Re: Labor Building - Window Replacement
SCO # 22-25223-01A Code: 42101 Item: 4218

Addendum No. 2

BID SET
A-4

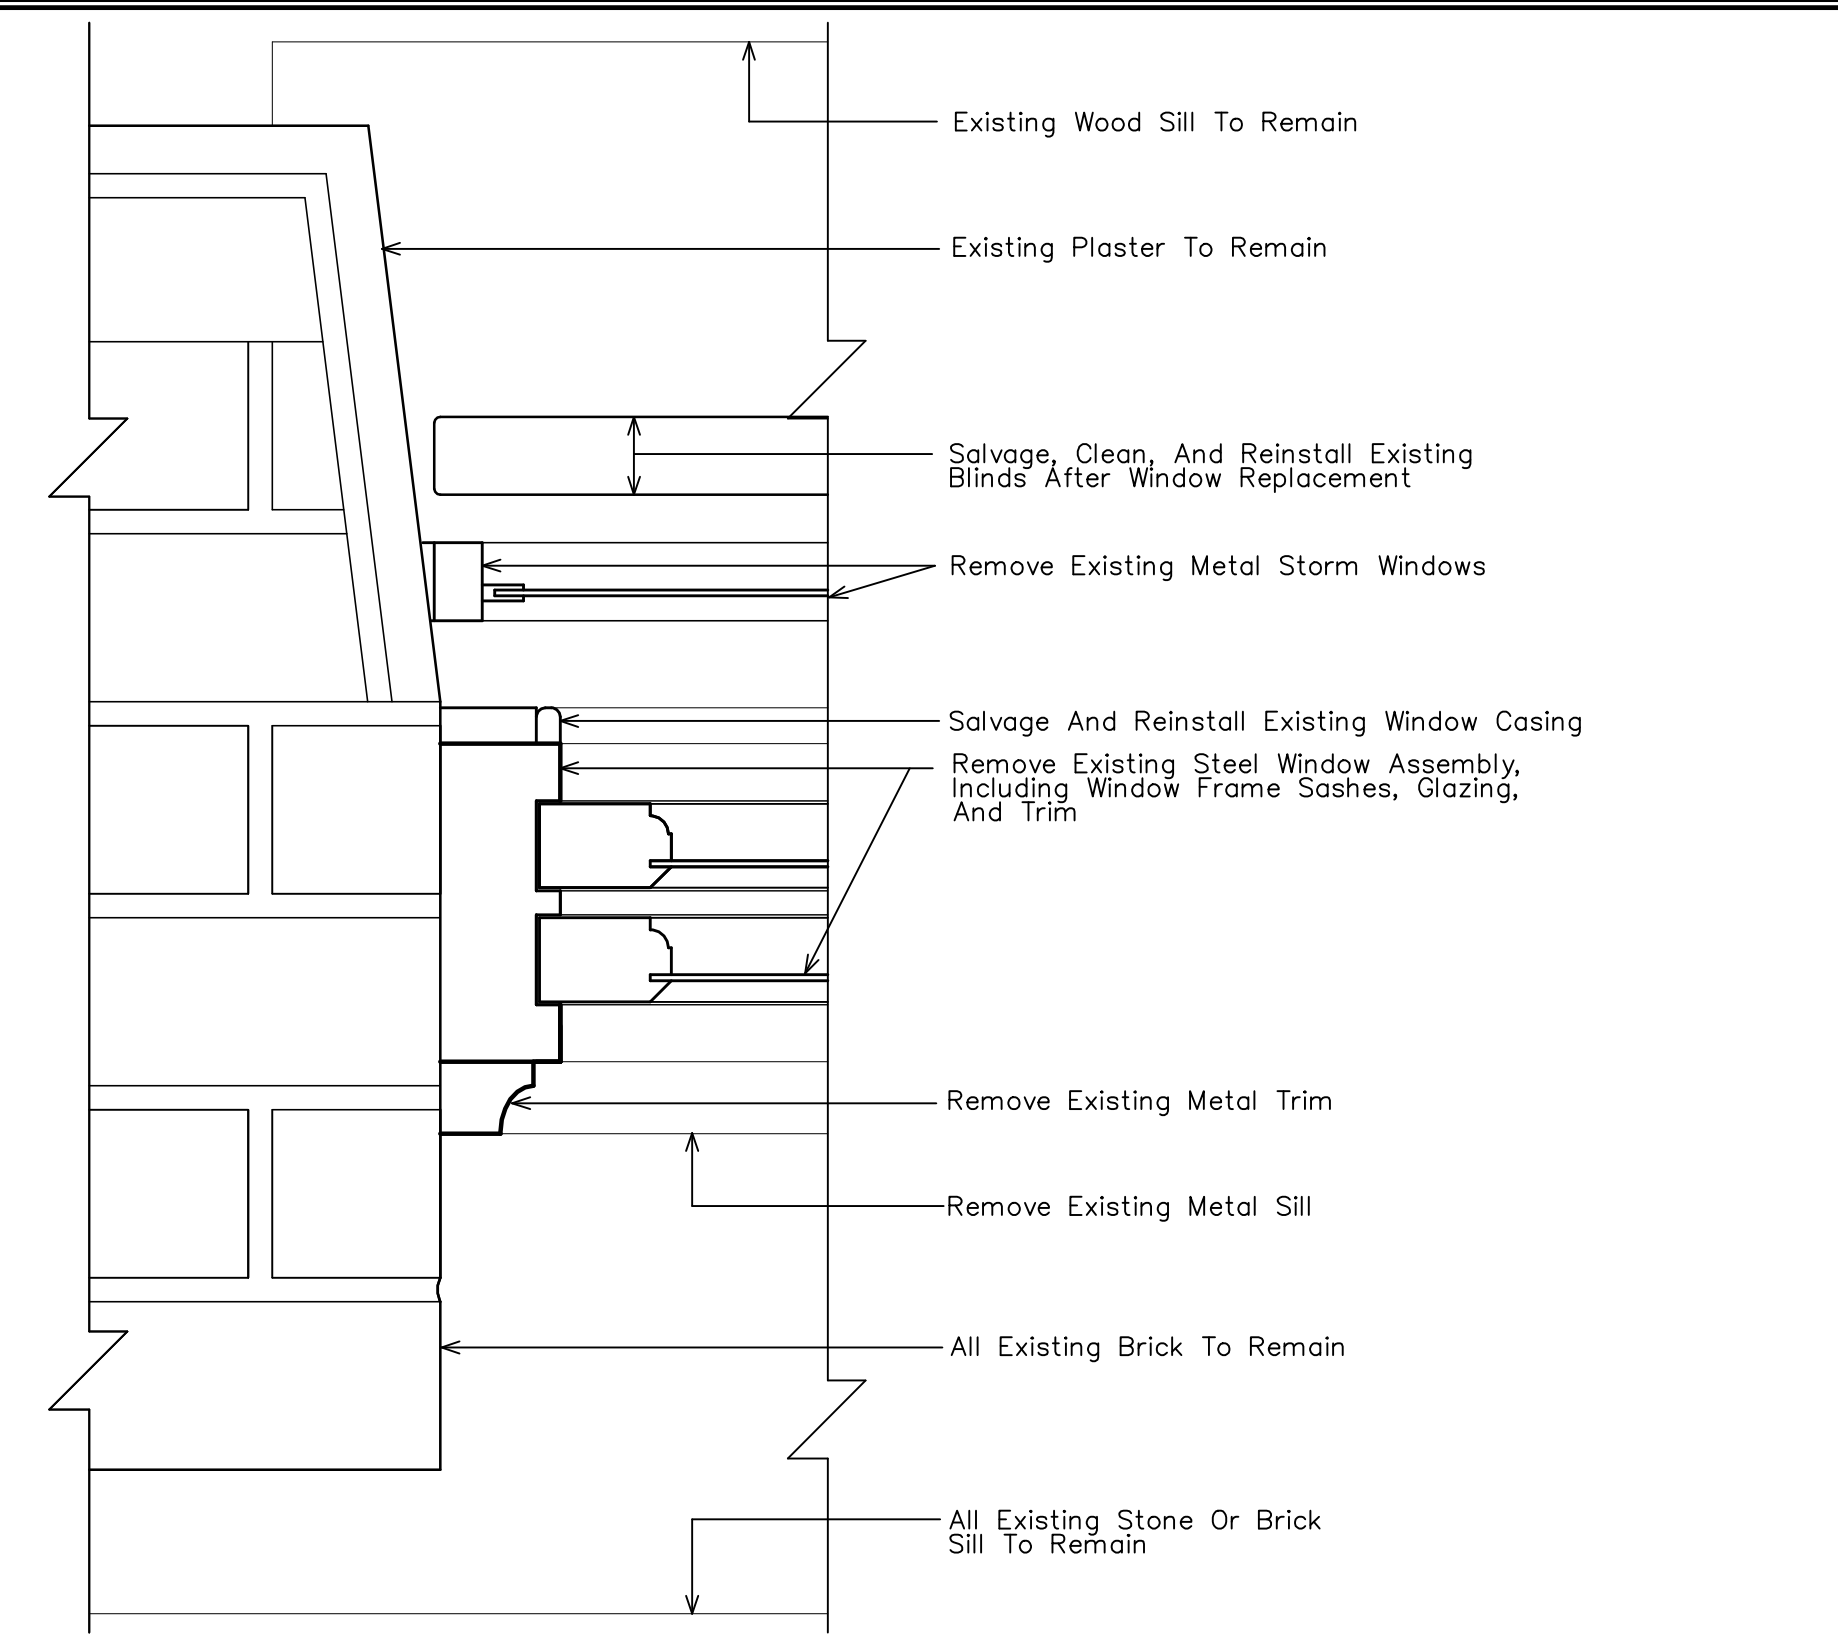
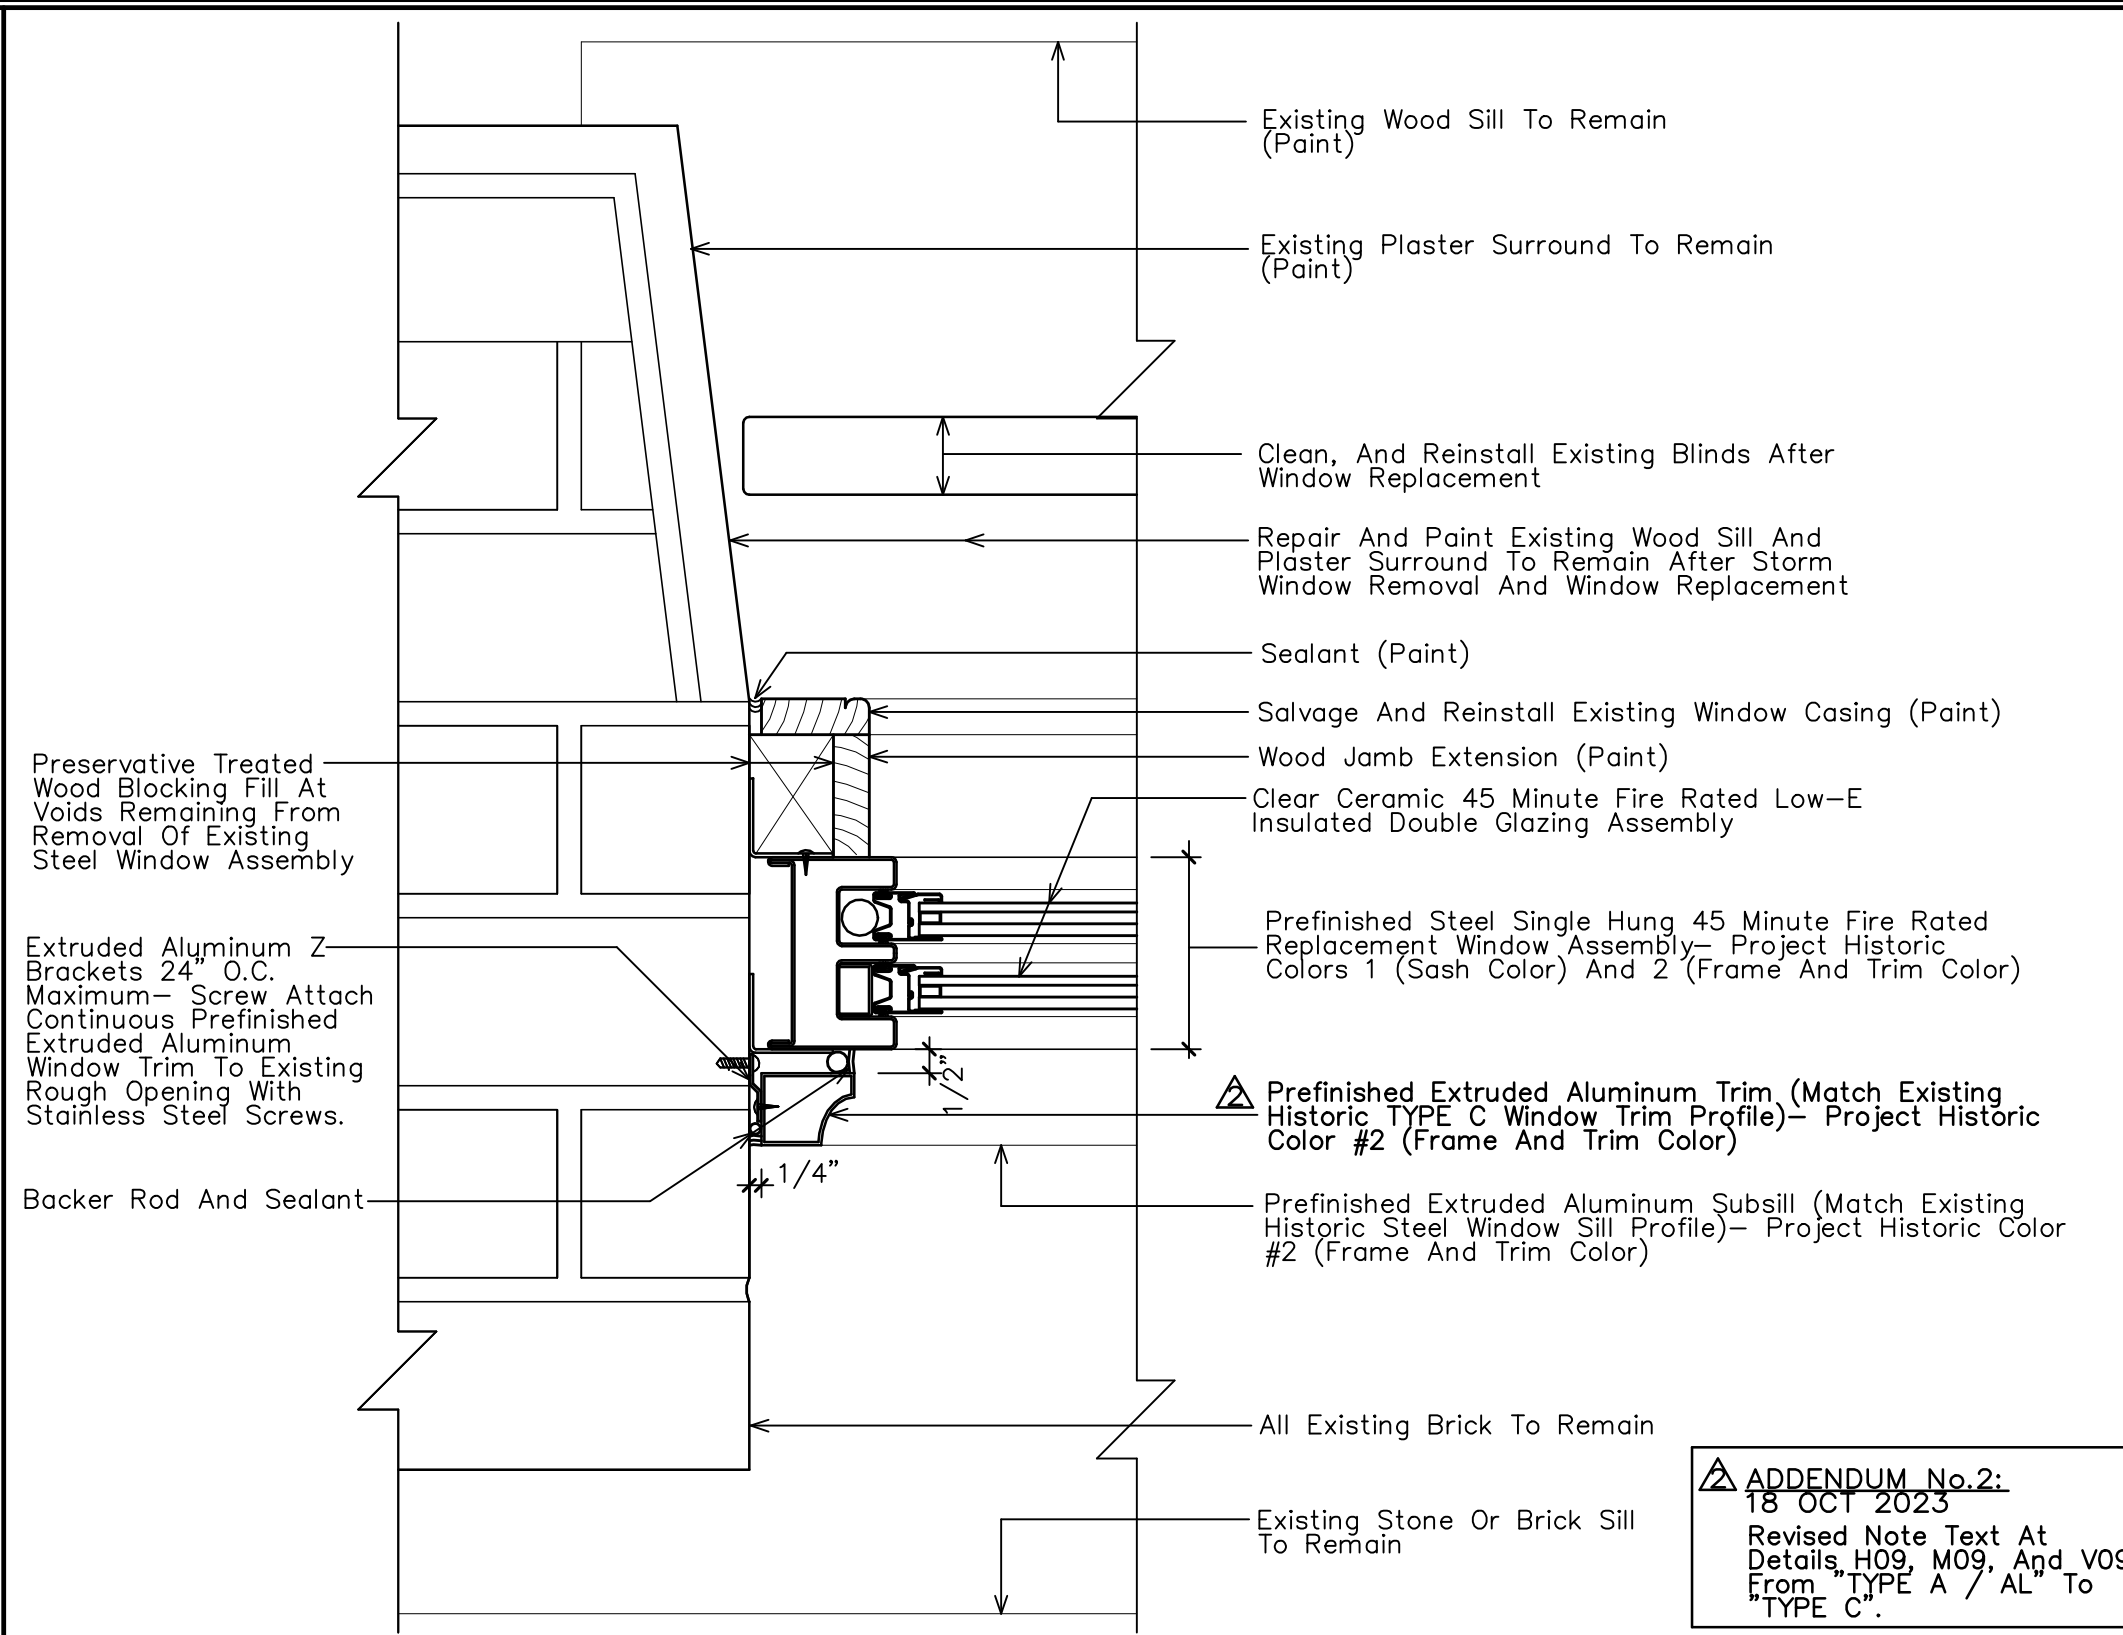
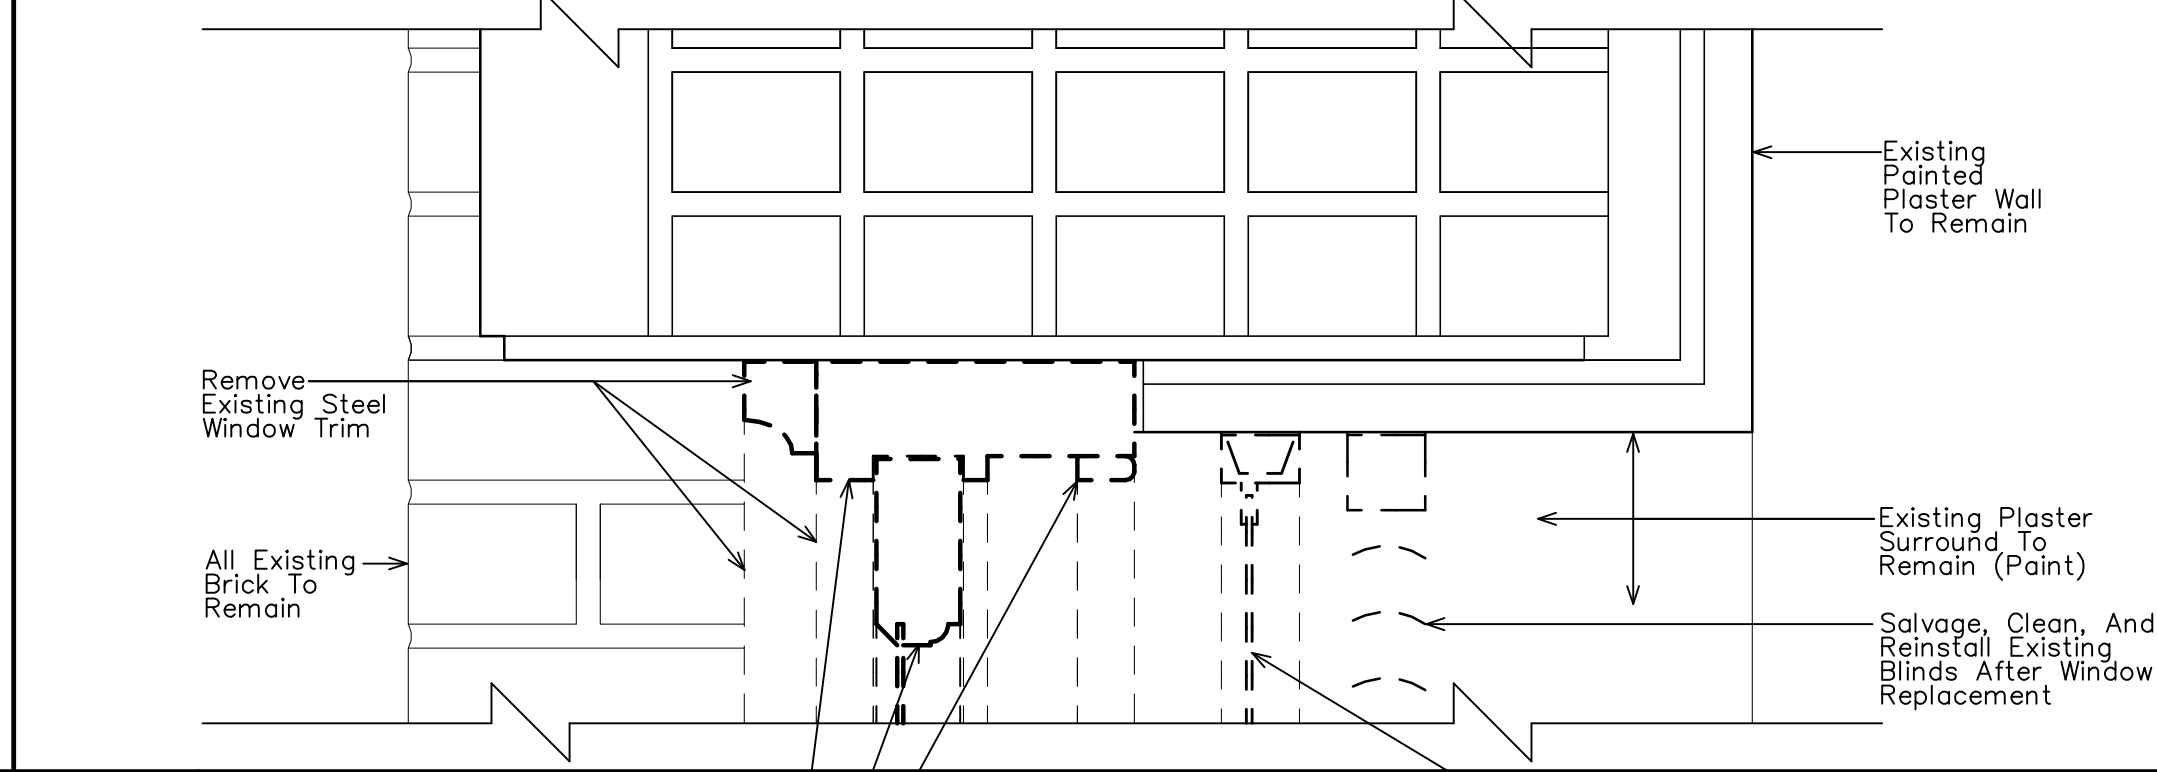
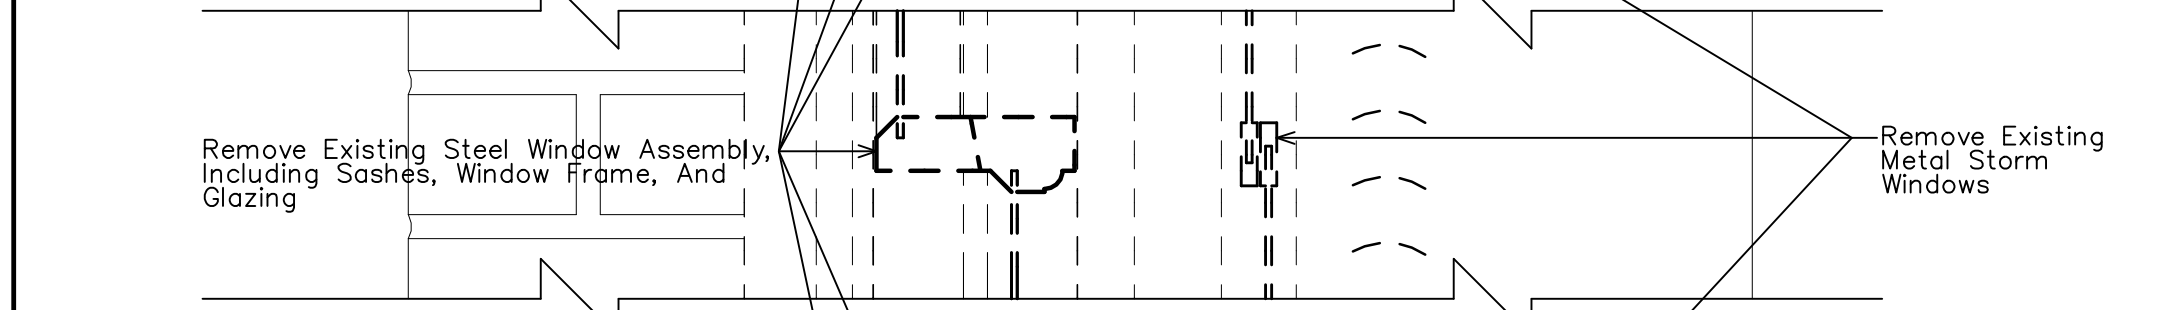
Revise Note Text at Details H09, M09, and V09 / Sheet A-6 From "TYPE A / AL" to "TYPE C".
Reissued Revised Drawing A-6 is included.

ADDENDUM No. 2:
18 OCT 2023
Revised Note Text At Details H09, M09, And V09 From TYPE A / AL To TYPE C.
